30S-1 RF LINEAR AMPLIFIER

SERVICE BULLETIN NO 2

PREVENT INTERMITTENT DROPOUT OF PLATE OVERLOAD RELAY

30S-1 Relay Shelf, Underside, Modification Instructions

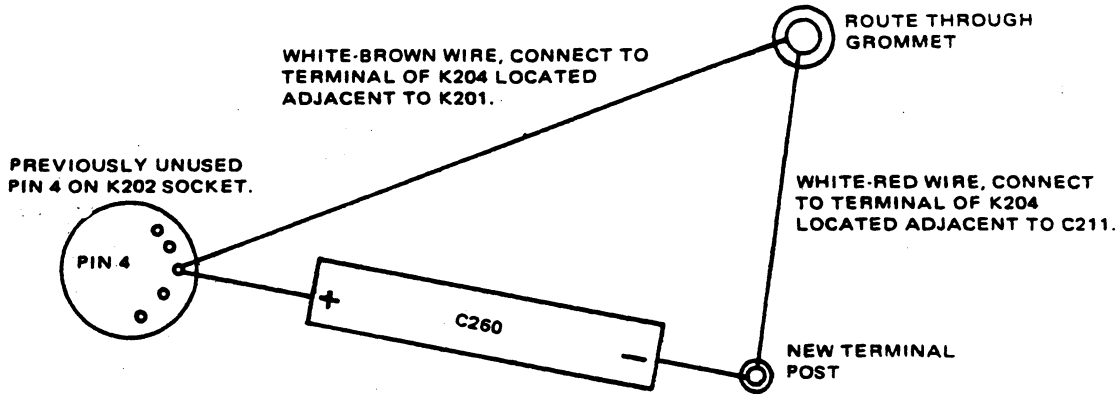
Some 30S-1 operators experience occasional dropout of plate overload relay K204, caused by short duration high plate currents. These currents sometimes occur after application of signal but before the exciter output is reduced by the alc circuits. A 2000- μ F, 6-volt dc capacitor installed across the energizing coil of the relay presents a low-impedance path to the audio envelope currents, but continues to provide dc overload protection. The instantaneous currents are not harmful to the 4CX1000A tube because of conservative tube operation.

1. Remove all power to unit and remove relay shelf and position it in a manner to gain access to lower side of shelf. Locate K202 socket and K204 mounting nut on the underside of the relay shelf, and remove mounting nut.
2. Install terminal post (306-0978-000) in place of removed K204 mounting nut.

- 3. Install 2000- μ F capacitor C260 (183-1311-000) and approximate 10-inch lengths of white-brown (439-7302-000) and white-red (439-7303-000) wires as shown in the illustration.
